Title of Change:
REVISE REFUSE PILE DITCHES CGD-6 AND CGD-7

RE: School House Canyon Refuse Pile Drainage Ditches CGD-6 and CGD-7, Cyprus Plateau Mining Company, Willow Creek Preparation Plant, ACT/007/038-97C, Folder #3, Carbon County, Utah

RE: Letter of Deficiency, School House Canyon Refuse Pile Drainage Ditches CGD-6 and CGD-7, Willow Creek Preparation Plant, ACT/007/038-97C, Folder #2, Carbon County, Utah

CGD-7 (UPPER)
CGRD-7

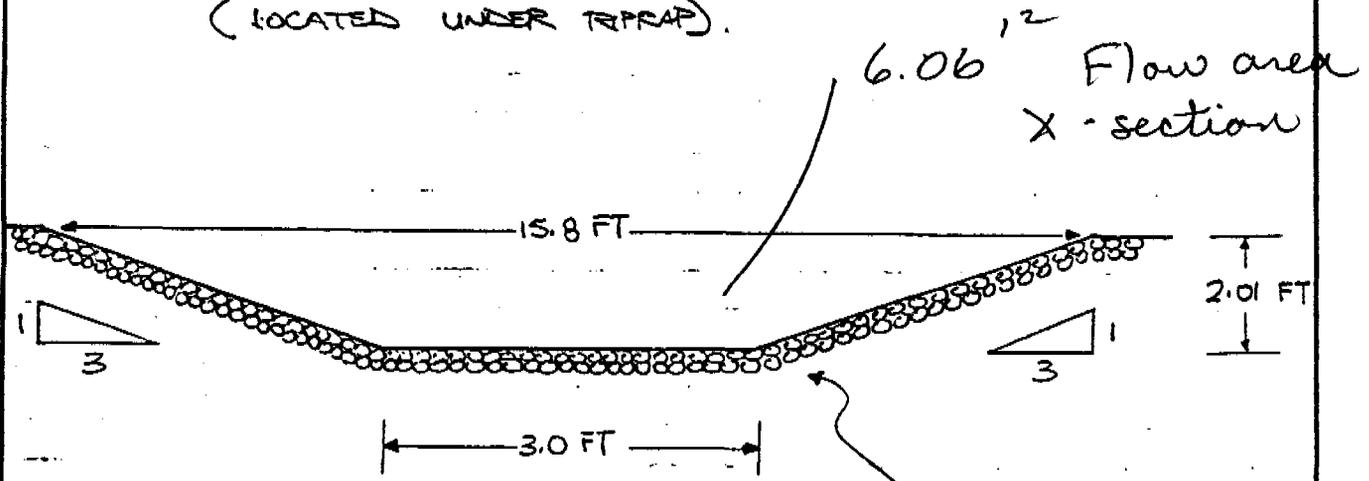
- 2) the designs are not P.E. certified, as is required by R645-301-512.140 and R645-301-712.
- 3) the design/cross section on page 47 for CGD-7 (upper), CGRD-7 is computed from a "Final operation peak flow" quantity (100 year 6 hour) storms of 22.82cfs. I assume this quantity is the same for the "current operation peak flow", but I'm not a hydrologist. Page 49, which is the design for CGD-6 (upper), CGRD-8, is computed from a "current operation peak flow". If the flow quantities for the final operation and current operation phases for the pile are the same, then the designs should be the same. The wording should reflect "current operation design" for both ditches; otherwise, we're right back in the same nightmare that we're trying to clear up.

CGD-7 upper Scale 1" = 3'

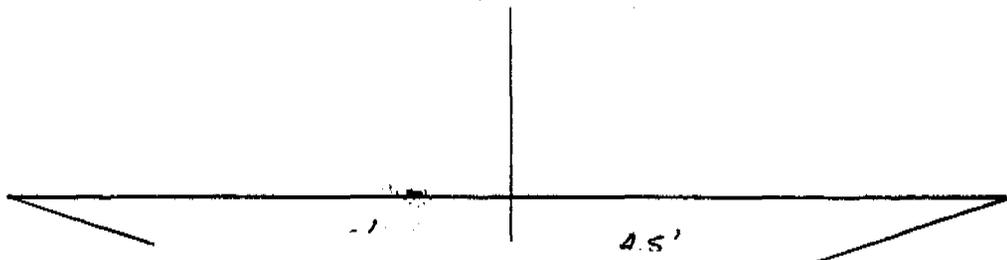
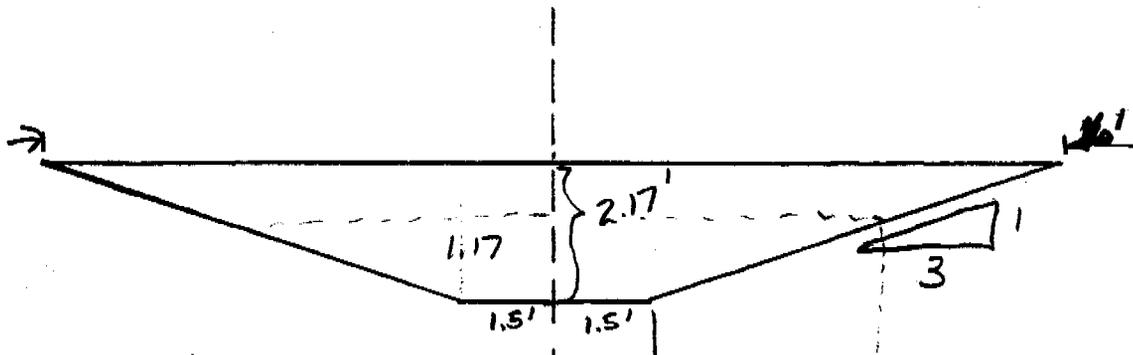
Compare X-sections
of old design to
new design -

$$A_0 = 7.6167'^2$$

$$A_N = 8.699'^2$$

$$A_0 = 6.06'^2$$

$$A_N = 6.9575'^2$$

$$\begin{aligned} \text{Total X-Sectional Flow Area} &= \\ &= [(3') 1.17'] + (1.17') [(3) (1.17')] \\ &= 3.51'^2 + 4.1067'^2 = \underline{\underline{7.6167'^2}} = \underline{\underline{A_0}} \end{aligned}$$

$$A_N > A_0$$

$$\Delta A = \underline{\underline{1.082475 \text{ } ^2}}$$
